RE: **Lot 32 Block 6 Unit 18 SAD 228
6547 Pato NW
Volcano Cliffs Subdivision
Grading and Drainage Plan
Engineers Stamp Date 8/21/2020 (D10D003M32)**

Based upon the information provided in your submittal received 8/20/2020, this plan is approved for Grading Permit.

DRAINAGE AND TRANSPORTATION INFORMATION SHEET (REV 6/2018)

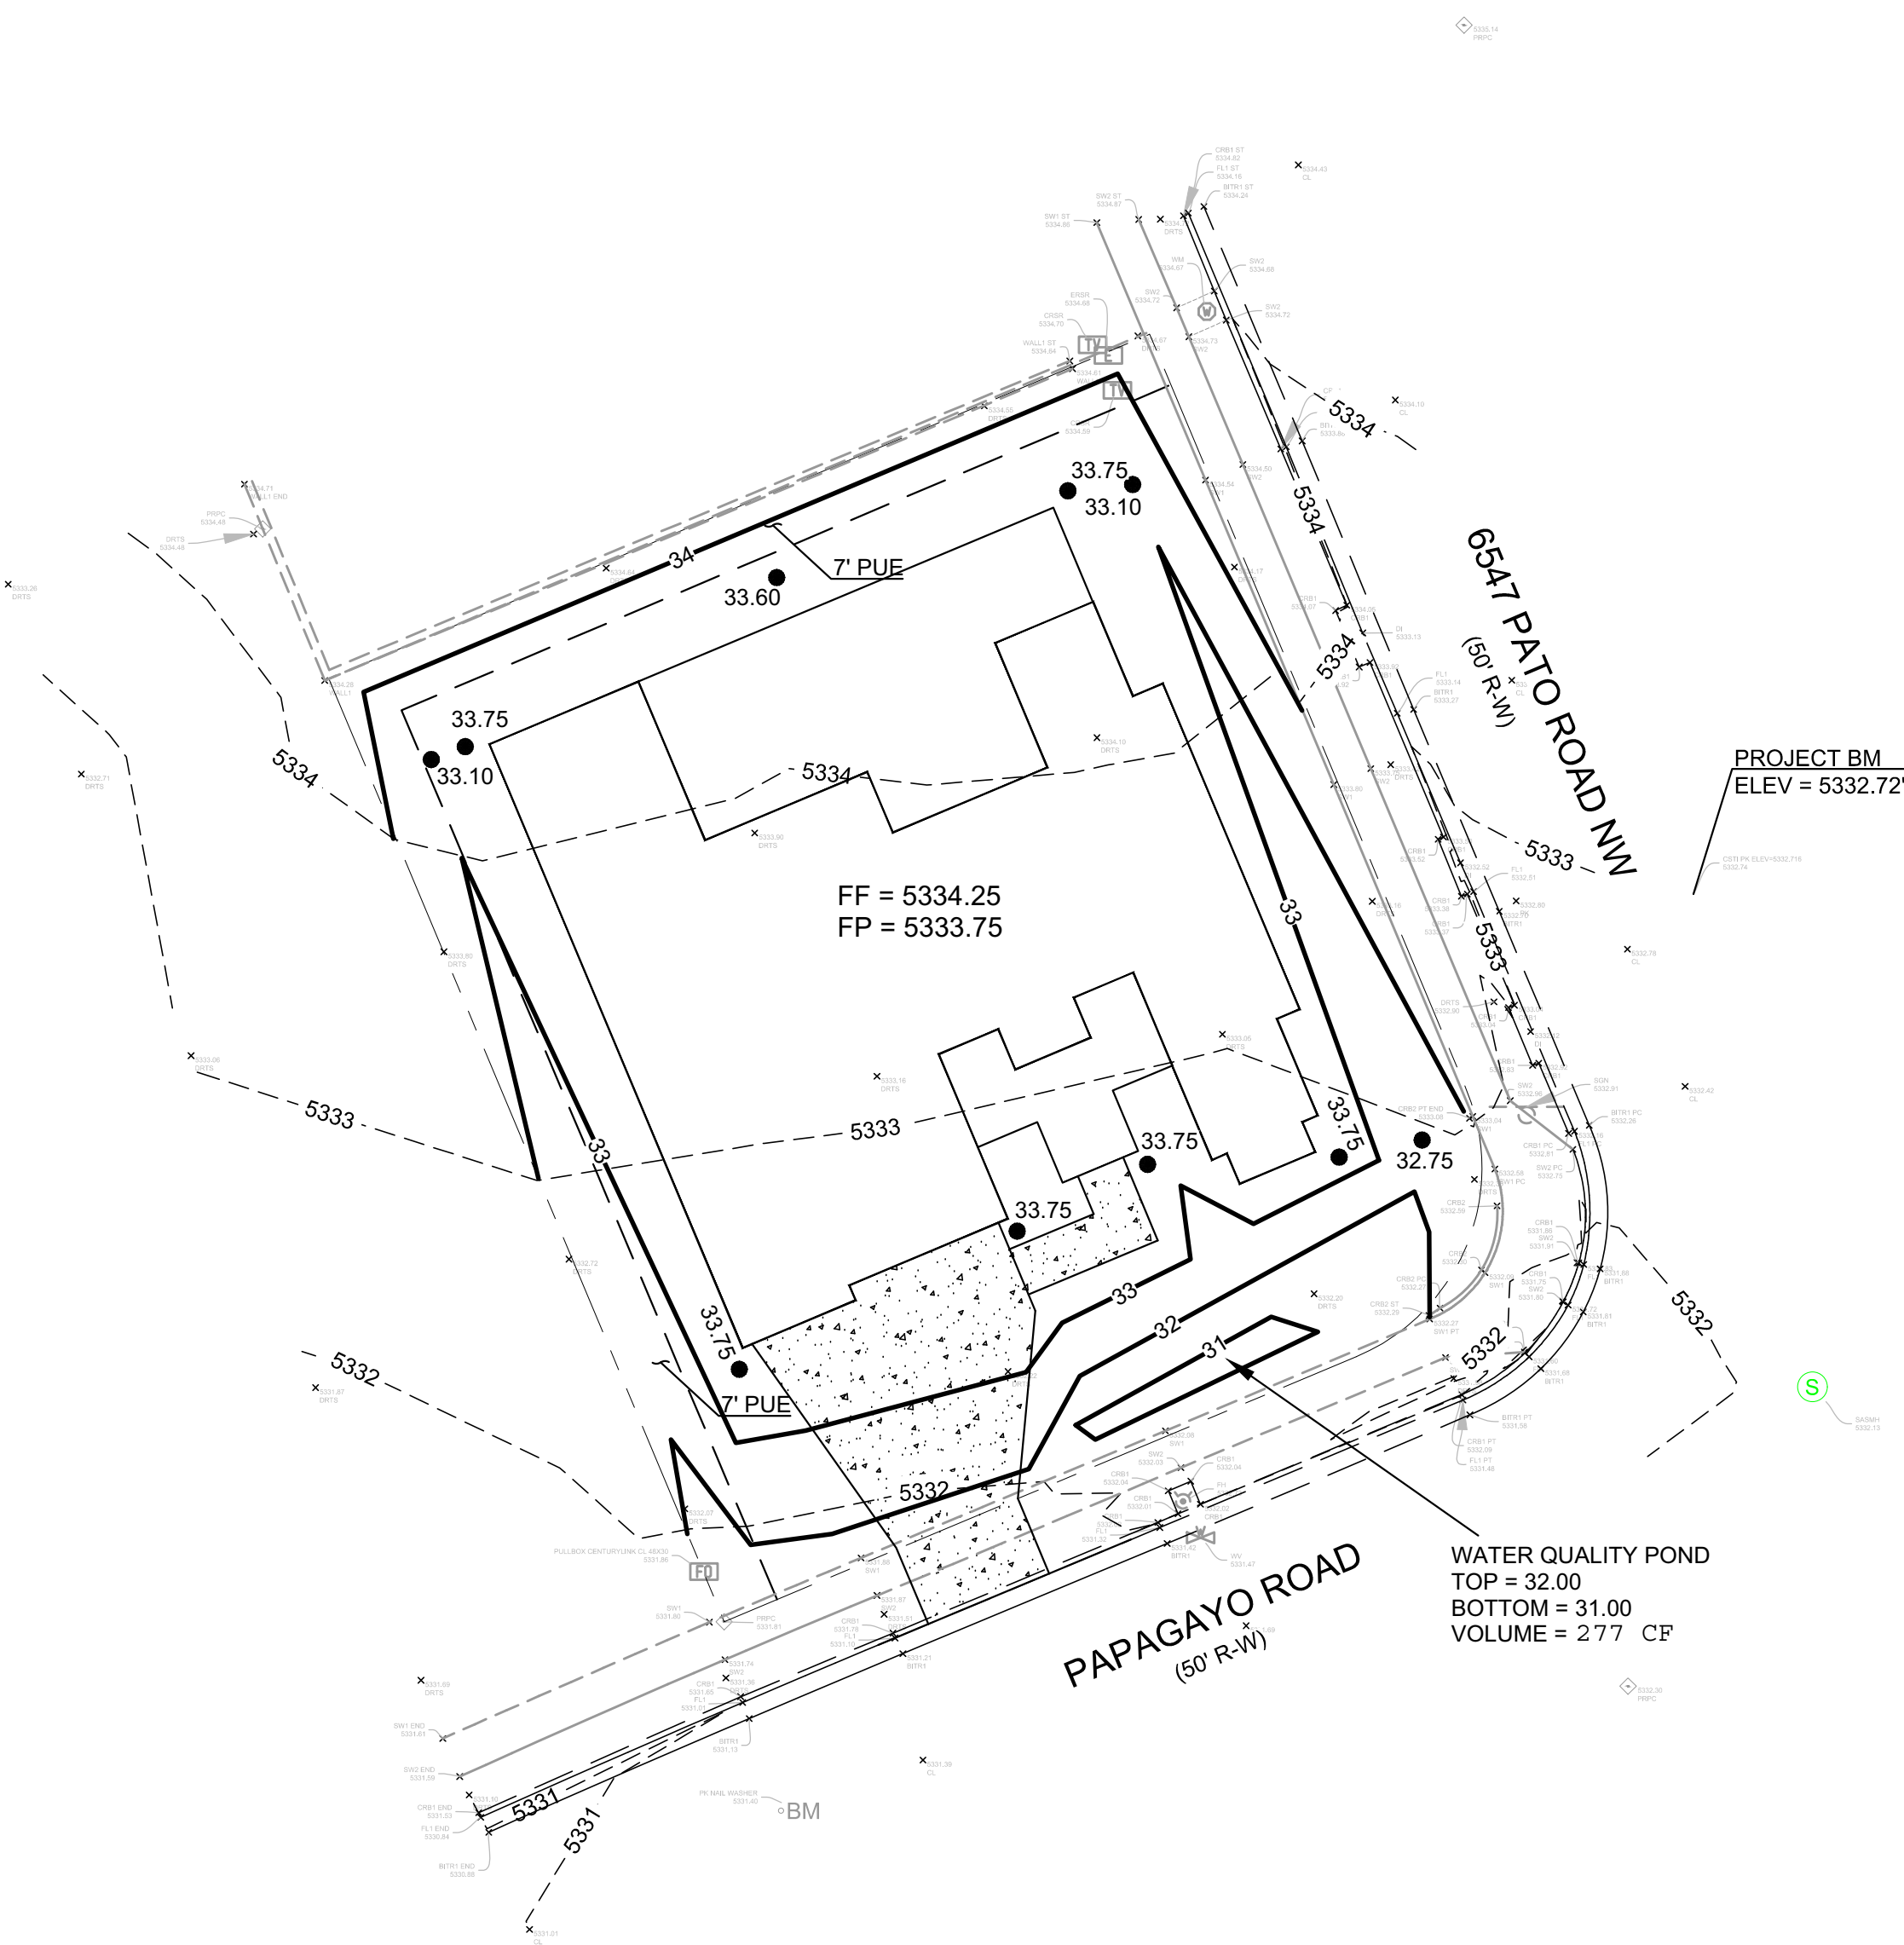
Prior to Building permit approval a Pad Certification will be required, provided by the Engineer or a registered Land Surveyor.

Advise the owner contractor not to use dirt as a ramp to climb the curb, use lumber or crusher fines for this purpose.

Reiterate to the Owner/Contractor that a separate permit for a garden/retaining wall must be obtained with the approved G&D plan and Pad Certification. Also, if a swimming pool is to be placed the grading and drainage plan will change and will need to be resubmitted.

Prior to Certificate of Occupancy release, Engineer Certification per the DPM checklist is required.
